**ZONING AMENDMENT,  
PLANNING APPROVAL &  
SUBDIVISION STAFF REPORT****Date: October 4, 2012**

<b><u>NAME</u></b>	Benjamin P Cummings
<b><u>SUBDIVISION NAME</u></b>	951 Government Street Subdivision
<b><u>LOCATION</u></b>	951 Government Street (West side of Marine Street, extending from Government Street to Church Street)
<b><u>CITY COUNCIL DISTRICT</u></b>	District 2
<b><u>PRESENT ZONING</u></b>	B-1, Buffer Business District
<b><u>PROPOSED ZONING</u></b>	B-2, Neighborhood Business
<b><u>REASON FOR REZONING</u></b>	Changing market conditions
<b><u>AREA OF PROPERTY</u></b>	1 Lots / 1.4 ± Acres
<b><u>CONTEMPLATED USE</u></b>	<p>Subdivision approval to create 1 lot, Planning Approval to allow a self storage facility in a B-2, Neighborhood Business District, and Rezoning from B-1, Buffer Business District, to B-2, Neighborhood Business District, to allow a self storage facility.</p> <p><b>It should be noted, however, that any use permitted in the proposed district would be allowed at this location if the zoning is changed. Furthermore, the Planning Commission may consider zoning classifications other than that sought by the applicant for this property.</b></p>

# SITE PLAN

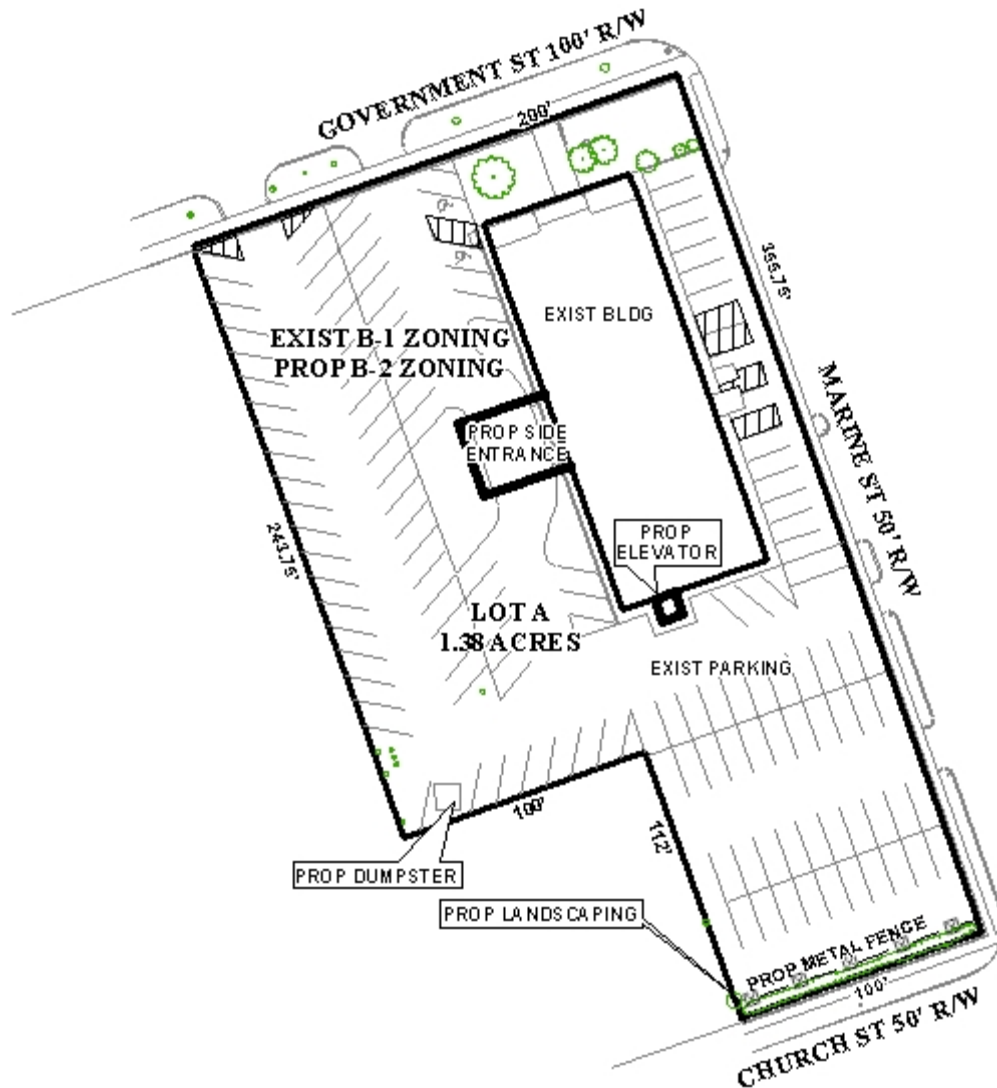
As the site was originally developed 53 years ago, it is not in compliance with the provisions of the current Zoning Ordinance, specifically the tree and landscaping requirements. The site plan submitted with the application only depicts new landscape area along the Church Street frontage, provides no information regarding overall landscape compliance, and shows no proposed trees. It is suggested that due to the "up zoning" request (where the citizens are asked via the City Council add value to the applicant's property), the site plan be revised to show some level of compliance regarding total landscape area requirements and at minimum frontage tree requirements along Marine and Church Streets (existing live oaks in the Government Street right-of-way eliminate the need for frontage trees in that area).

The site also has traffic circulation issues. The site plan only modifies site circulation around a proposed entry canopy, otherwise leaving the site as is. The site is a mixture of one-way and

two-way parking aisles, angled parking and 90-degree parking, and parking that backs out into Marine Street. It is recommended that the site plan be modified to eliminate as many existing curb-cuts as possible, so that the site retains one access point onto Government Street, and one compliant two-way curb-cut is provided onto Marine Street. All other curb-cuts should be closed and landscaped to match existing right-of-way greenspace. It should be noted that the curb-cut closure includes the elimination of the parking spaces along Marine Street that require backing out into the right-of-way. As Government Street is also a US Highway, curb-cut modifications must be approved by ALDOT, in addition to Traffic Engineering.

The site abuts residential uses, and the submitted site plan depicts a privacy fence. It should be noted that it is the responsibility of a commercially developed site to provide an adequate buffer compliant with Section 64-4.D.1. of the Zoning Ordinance for where the site abuts residential uses. A 10-foot wide residential adjacency buffer should also be depicted where the site abuts residential uses. The buffer can be used for parking, but it cannot be used for dumpster placement, thus the site plan should be revised to relocate the proposed dumpster to be a minimum of 10-feet from the residential property lines, and not within any other required front or side yard setbacks.

As the site is located in an historic district, it is recommended that the perimeter of the parking lot be bounded by a 10 foot wide landscape strip, that includes trees, shrubs and possibly fencing (fencing shall not exceed 3-feet in height when in the 25-foot setback area). Such a perimeter parking lot buffer will mitigate the negative impact of the existing parking area on the historic district.

Regarding the amount of parking on the site, no information was provided with the application to indicate if an office will be part of the renovation of the existing building into a self storage facility. Typically such facilities do have small offices, and parking for such facilities are minimally based upon the office size. As the site is proposed to have approximately 121 parking spaces before any suggested revisions, it would appear that there will be an excess of parking and / or paved area on the site. Therefore, the site plan and narrative should be revised to indicate if an office will be part of the renovation, the size of the office proposed, and how many parking spaces will minimally be required and/or desired as part of the reuse of the site.

- 1) Revision of the site plan to reflect Traffic Engineering comments (*This site is located on an ALDOT maintained roadway. Government Street and Marine Street should each be limited to one curb-cut, with size, location and design to be approved by ALDOT (Government Street) and Traffic Engineering (both frontages), and conform to AASHTO standards. The Government Street driveway should be constructed as a right-in, right-out only, in the vicinity of the eastern driveway, to provide separation from the adjacent property's driveway. Note: the existing driveway radii do not appear to be illustrated accurately. The curb-cut on Marine Street should be two-way with no turning restrictions. Parking aisles will need to be adjusted to allow for internal circulation. Any parking stalls that require backing or maneuvering in the right-of-way should be eliminated. This includes the parking adjacent to the building along Marine Street, and internal angled spaces near the Government Street driveway. The western site perimeter will need physical obstructions to prevent cross access from the adjacent business and residence.*);

- 2) Revision of the site plan to include information regarding the amount of office space to remain in the building, the provision of parking spaces adequate to serve any storage office use on site and spaces necessary for customers;

- 3) Revision of the site plan to reflect Engineering comments (*1. Provide all of the required information on the Final Plat (i.e. signature blocks, signatures, certification statements, legal description, required notes). 2. A signature block and signature for the Traffic Engineering Department shall be placed on the Final Plat. 3. Dedicate ROW radius at the corner of Government St and Marine St, and at Church St and Marine St, with the size to be approved by Traffic Engineering and Engineering.*);

- 4) Revision of the site plan to reflect Urban Forestry comments (*Property to be developed in compliance with state and local laws that pertain to tree preservation and protection on both city and private properties (State Act 61-929 and City Code Chapters 57 and 64). Full compliance with frontage tree planting requirements of the Zoning Ordinance; number and location to be coordinated with Urban Forestry due to existing mature Live Oak Trees along Government Street and the planting of one understory tree for every 20 parking spaces to be planted within interior of the lot to break up the expanse of paving.*);

- 5) Revision of the site plan to depict the 10-foot wide residential buffer, and relocation of the proposed dumpster to be outside of any required buffer; and

- 6) Revision of the site plan to eliminate the commercial use of the rear 112 ± feet of the property.
